Access Compliance Report

Public Rights-of-Way

(Pedestrian Signals)

Intersection ID: N/A	Main Street:	Cross Street: N/A	Location: N/A
ADA ID: A6F69AAE35E1	Signal Type: One Push Button-Non APS	Overall Compliance: No	Severity Score: BTN 1: N/A BTN 2: N/A No BTN: N/A
Codes/Mitigation Info/Possible Solution		Field Measurements/Component Compliance

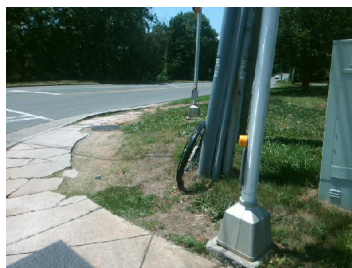
Surveyor Notes: TEXT HT 1/2

PROW/ADA: R410.6, R404.2, R404.3, R406.2

Possible Solutions: Remove & Replace Sign.
Remove and Replace Clear Space.
